3 Volt Intel StrataFlash® Memory

28F128J3A, 28F640J3A, 28F320J3A

Specification Update

April 2002

Figure 1. AC Waveform for Standard Word/Byte Read Operations

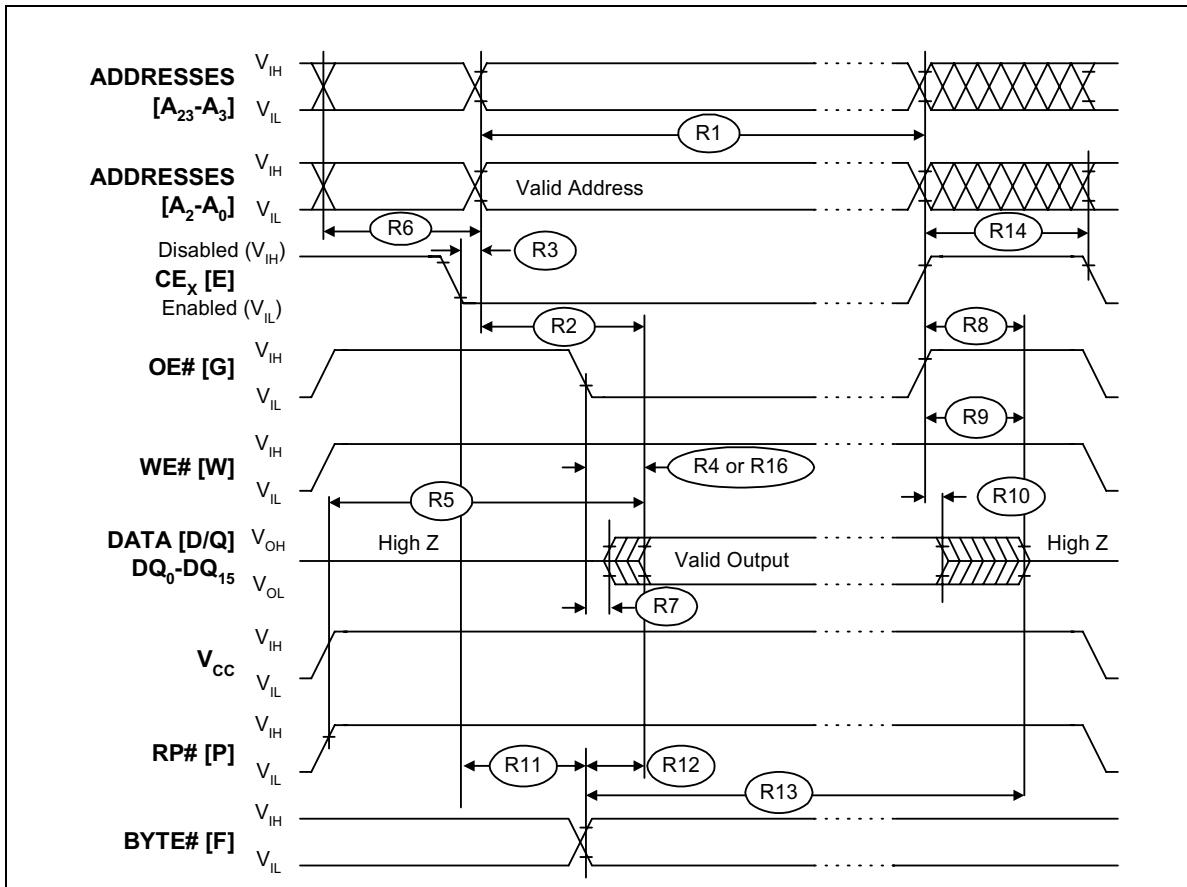
Problem: Devices need the parameter $t_{ELQX} = 150$ ns minimum. CE low to output in low Z (t_{ELQX}) is designated as R6 in Figure 1, in this Specification Update revision.

Problem: Devices need the parameter $t_{ELAV} = 500$ ns maximum. Chip Enable to Address Valid (t_{ELAV}) is designated as R3 in Figure 1, in this Specification Update revision.
